# Value Engineering Study Report

**US 641 Connect Eddyville to Fredonia**  
Kentucky Transportation Cabinet (KYTC)

Value Engineering Study 2019-12-4  
Item #1-187.31 (#1-187.50 and #1-187.60)

*Caldwell and Lyon Counties, Kentucky*

**VE RECOMMENDATION NO. 6:  
ALTERNATIVE 2+1 TYPICAL SECTION**

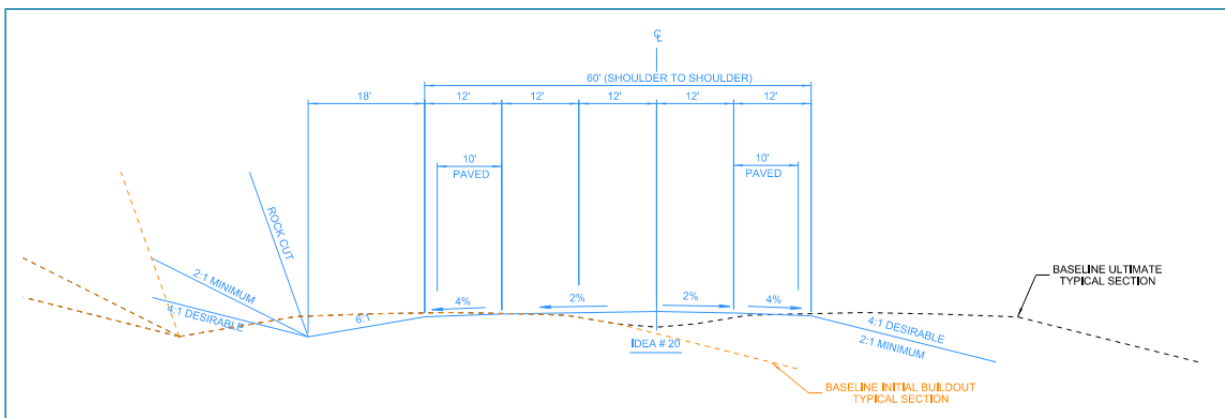
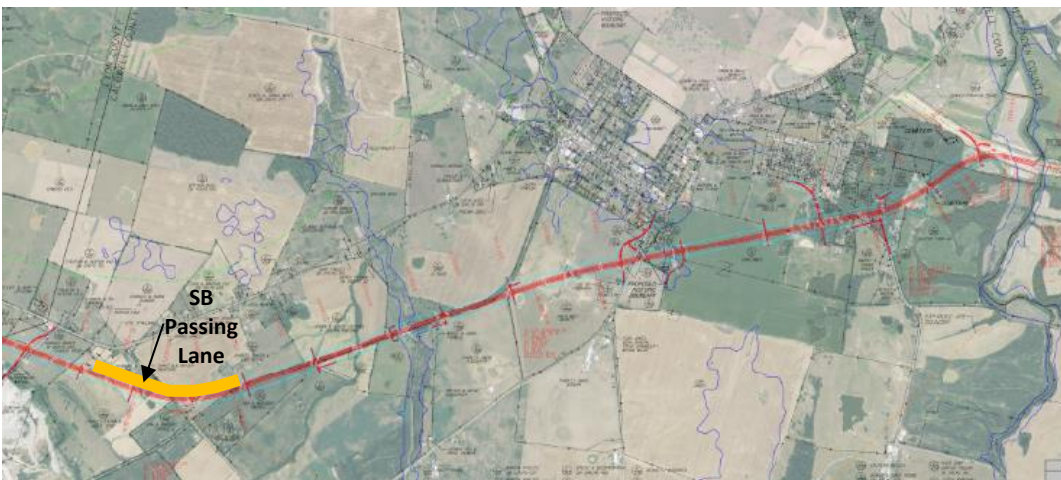
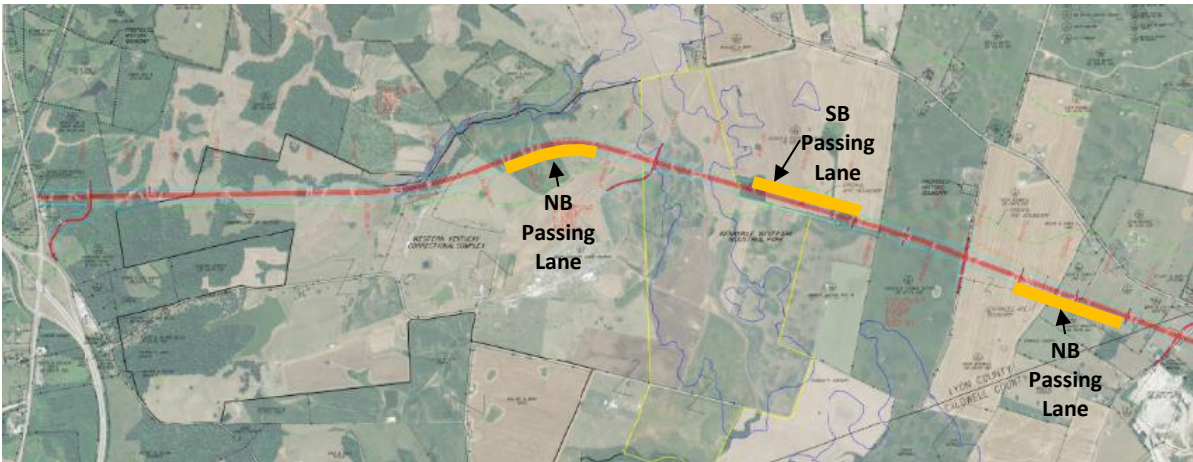
A basic sketch of the location of the passing lanes as discussed is shown below.

From a safety perspective, the 2+1 provides an improved predictive safety performance to the full-build option. Based on the calculated crashes (IHSDM) and cost breakdown, the 2+1 should show an improvement of \$5M of societal crash cost savings.

This option also affords the ability to expand the typical section to a 4-lane ultimate configuration should the traffic volume dictate. The pavement width is comparable to a modified Alabama 55 typical section with 4x12' lanes, 4' flush median, and 2' shoulders (which could be expanded for safety benefits [see VE recommendation 5]). Additionally, the bridges would need to be expanded to accommodate this scenario.

**Operational Analysis:**

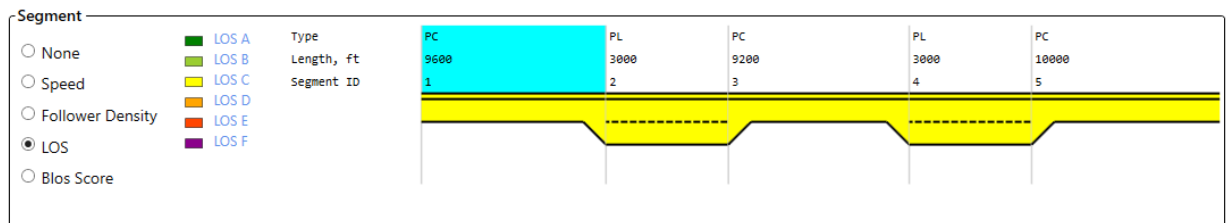
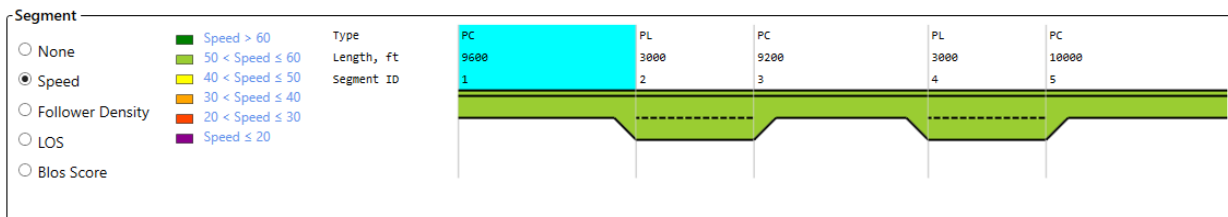
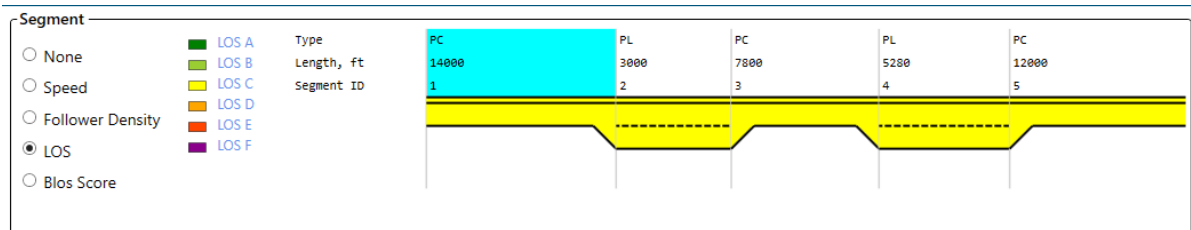
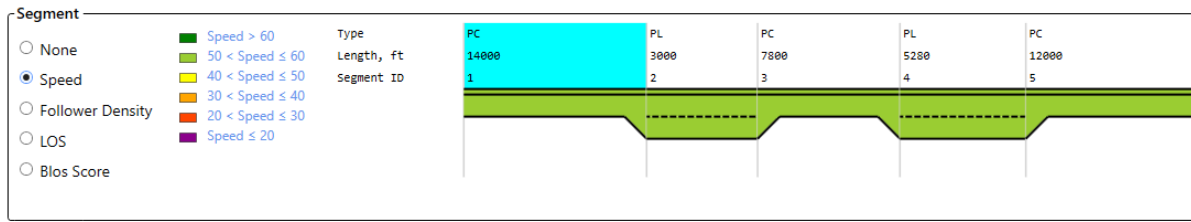
HCS7 Two-Lane Highways module was used to analyze the operations for the 2+1 configuration. Assumptions from the revised volume projections were used to determine DHV volumes. *It should be noted that the revised traffic projections are likely conservative when comparing to historic growth trends for this roadway and similar facilities.* A K factor of 10% was used to derive the volumes, and it was assumed that the directional split would be even 50/50. The volumes used for analysis range from 550 to 730vph. The truck percentages ranging from 25%-34% were used throughout the corridor. Based on those assumptions it is anticipated that the 2+1 configuration will operate with adequate speeds (>50mph) and adequate LOS (LOS C) through the 2040 design year. The analysis was based on peak volumes which are likely to occur one-hour per day, the remaining hours of the day will operate better than the LOS C conditions. The images below show the results of the DHV analysis for NB and SB.
